CLIENT
IKEA TEMPE

PROJECT
Proposed Bulky Goods Development; Princes Highway Tempe, Sydney, NSW

DRAWING
LANDSCAPE MASTER PLAN

DATE	SCALE	DRAWN
March 2010	1:500 @ A0	AMS
PROJECT No.	DRAWING No.	ISSUE
0907	L01	C

LANDSCAPE PLAN

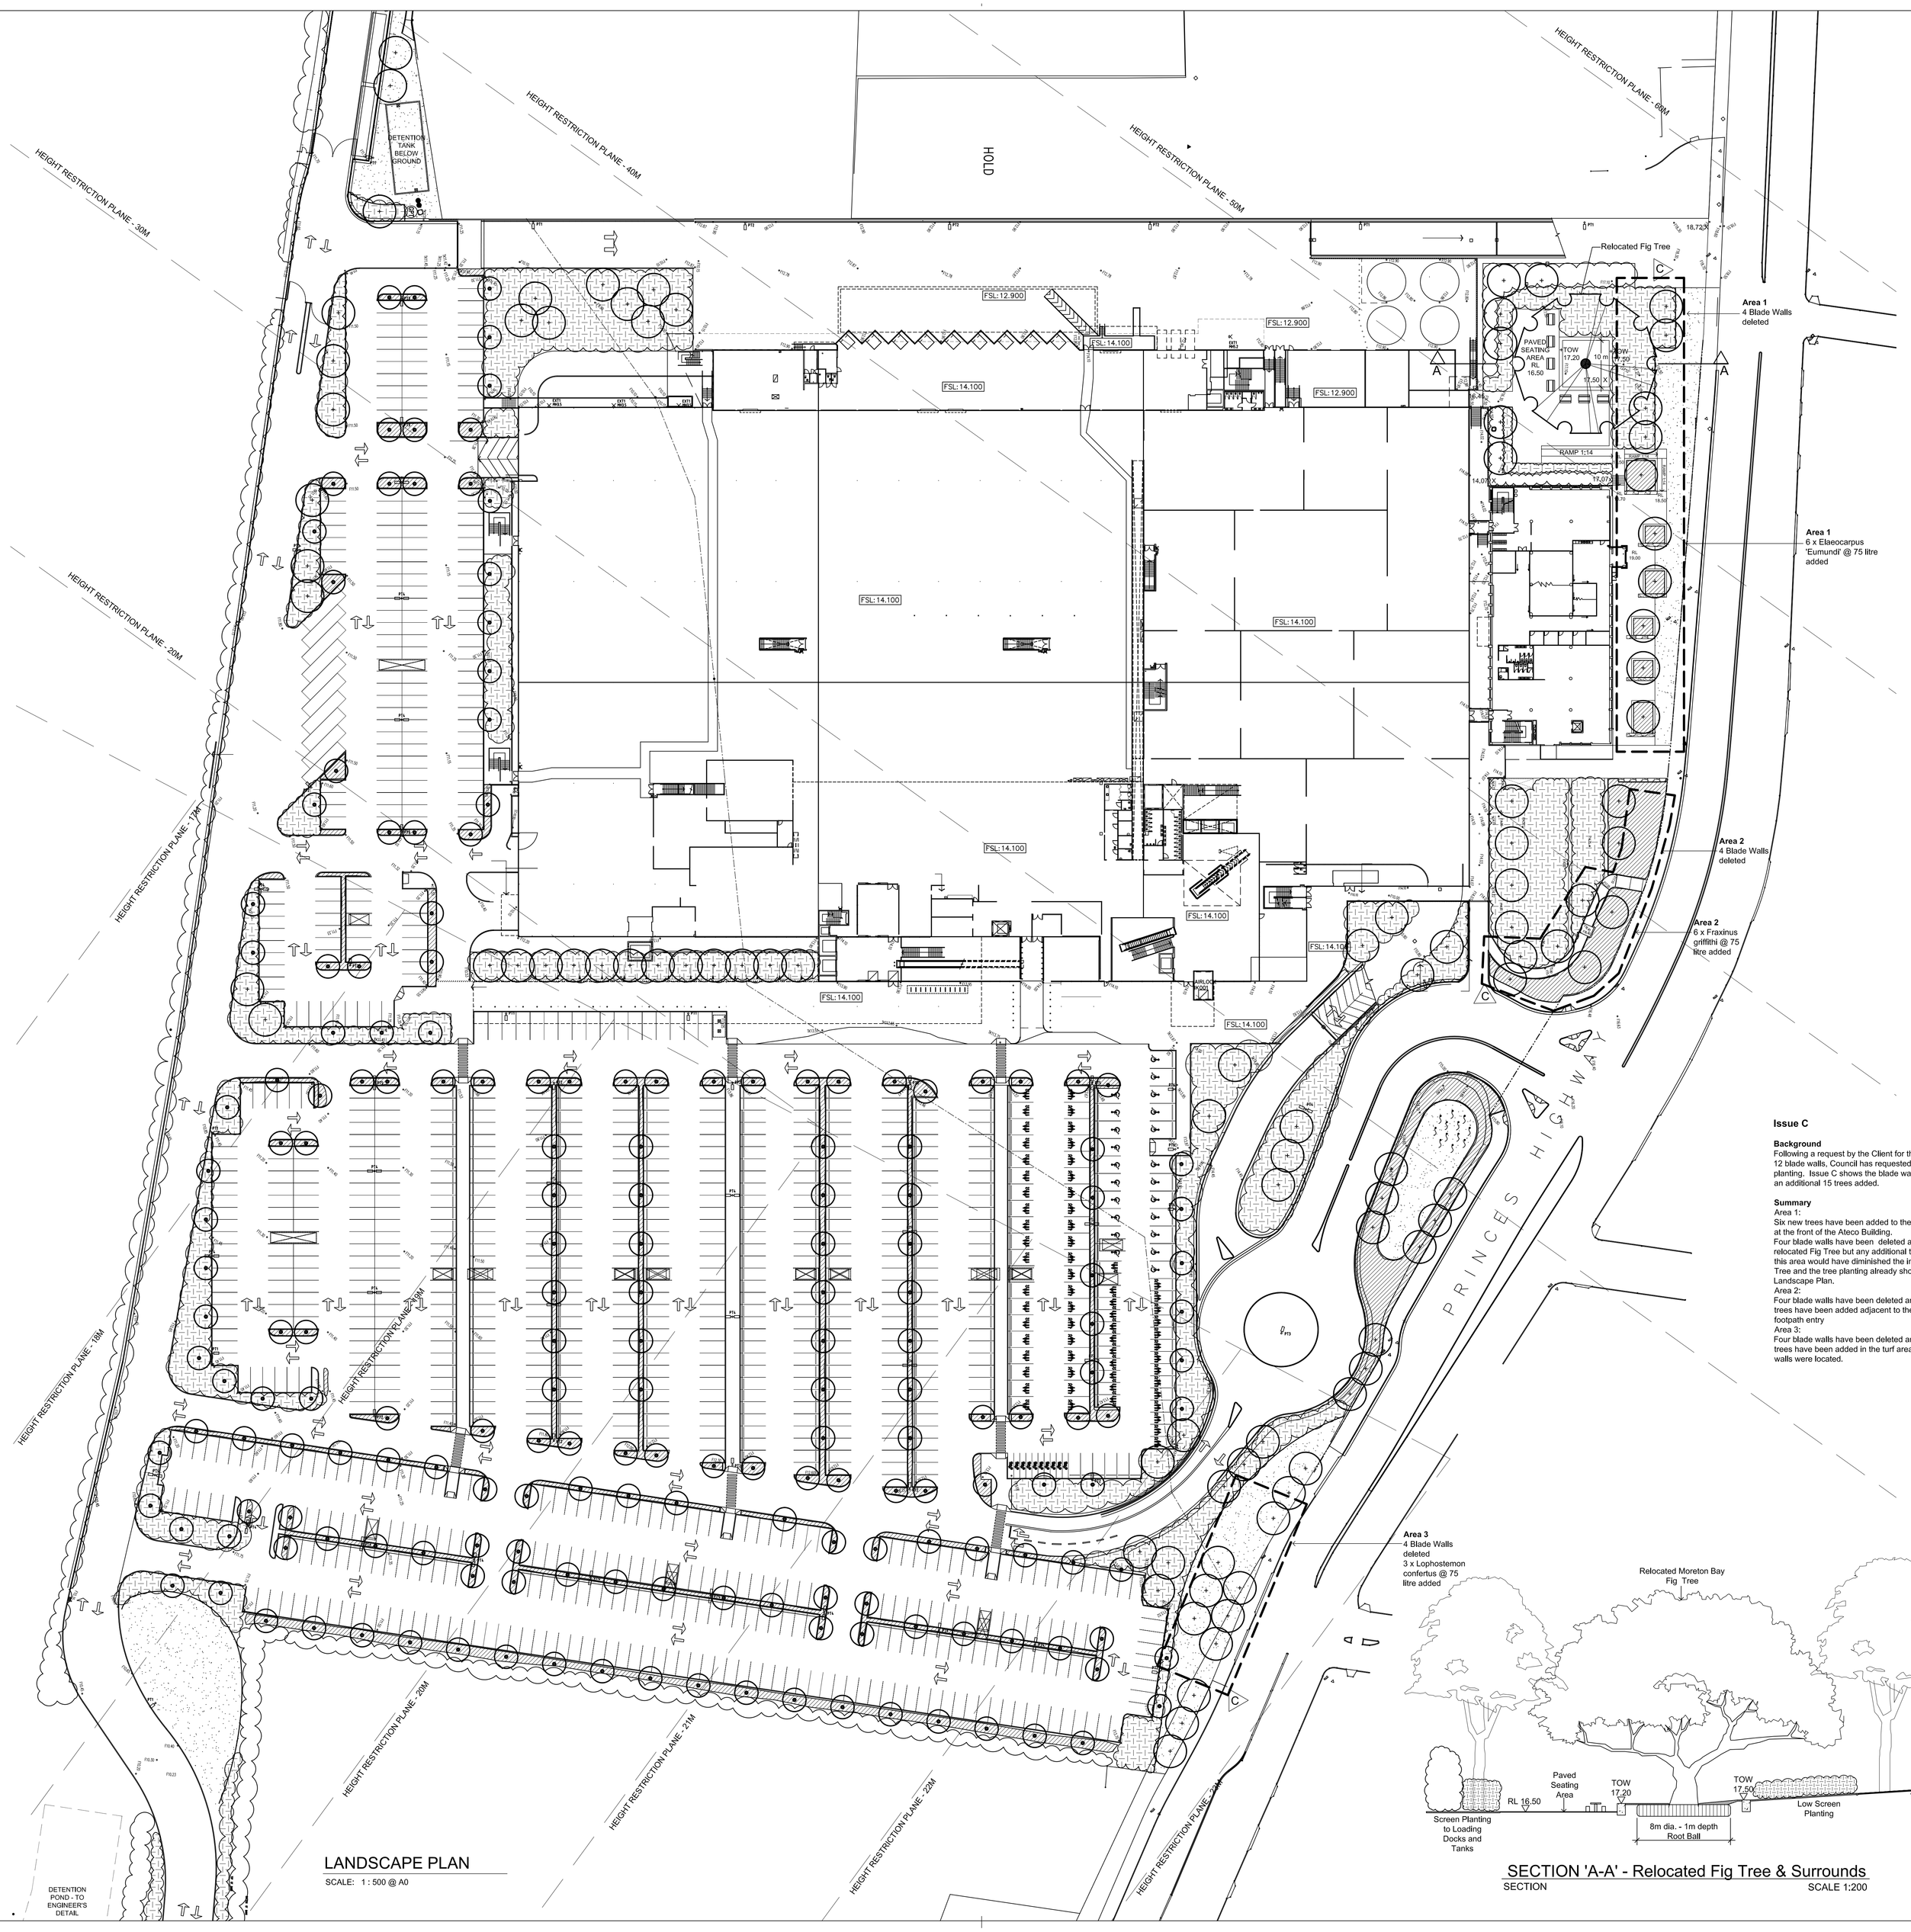
The main changes to the Site Plan are as follows:
1. Road widening of 3metres to the Princes Highway to allow for slip lanes to the carpark entry
2. Redesign of the carpark layout and deletion of the proposed Bio-swales within the carpark. The latter are replaced by detention ponds/tank on the access roads to Bellevue and Smith Streets
3. The inclusion of Water Storage Tanks in the area previously set aside for the relocated Fig Tree and the associated Seating Area

Conditions from the Department of Planning as part of Condition B7, are as follows:
- Relocation of the existing Moreton Bay Fig Tree to the staff outdoor recreation area
Response: The Tree has been moved further west and a seating has been incorporated beneath the tree. Refer Section A+A. The location of the Tree will provide a greater public benefit to the streetscape as it is more visible. The tree canopy will also have a larger area in which to spread. The paved seating area under the tree is larger than the previous seating area and its new location provides easier pedestrian access from the Ateco Building.

- Provision of a minimum of sixteen (16) trees along the Princes Highway frontage in cluster planting
Response: 21 new trees have been included immediate to the Princes Highway frontage

- Appropriate landscape screening of the gabion walls with climbing plants
Response: The 4metre gabion walls along the north-east boundary have been deleted. All other gabion walls are low walls approx. 500mm high
- A minimum of twelve (12) trees in planters at the entrance to the store
Response: 12 new trees have been included in the raised planter between the building and the covered walkway to the south of the store entrance
- A variation of tree species within the carpark
Response: Three tree species have been selected for the main carpark. Species selection is related by necessity to flight path height restrictions and the species ability to survive in carpark planting islands.

Part B- Prior to Issue of Construction Certificate - Condition B1 (d)
- The at-grade car park layout shall be amended to provide for the planting of a total of 270 super advanced trees

Background
Following a request by the Client for the deletion of 12 blade walls, Council has requested additional tree planting. Issue C shows the blade walls deleted and an additional 15 trees added.

Summary
Area 1:
Six new trees have been added to the raised planters at the front of the Ateco Building.
Four blade walls have been deleted adjacent to the relocated Fig Tree but any additional tree planting in this area would have diminished the impact of the Fig Tree and the tree planting already shown on the Landscape Plan.
Area 2:
Four blade walls have been deleted and six new trees have been added adjacent to the ramped footpath entry
Area 3:
Four blade walls have been deleted and three new trees have been added in the turf area where the walls were located.

Response: 198 new trees are proposed in the at-grade carpark. Rather than super-advanced size, 25 litre size is recommended. This recommendation is due to the level of the capping over the tip site and the need for the trees to establish themselves in this restricted environment. Given that they are native species their growth rate will be greater if planted at a less mature stage. The trees will be protected with proper staking and a 24month Plant Establishment/ Maintenance Period to ensure their survival. All planting areas are to be backfilled with imported planting soil and mulch and irrigated.
The tree species selected for the at-grade carpark are restricted in mature height to between 6metres and 8 metres due to Sydney Airport flight path height restrictions.
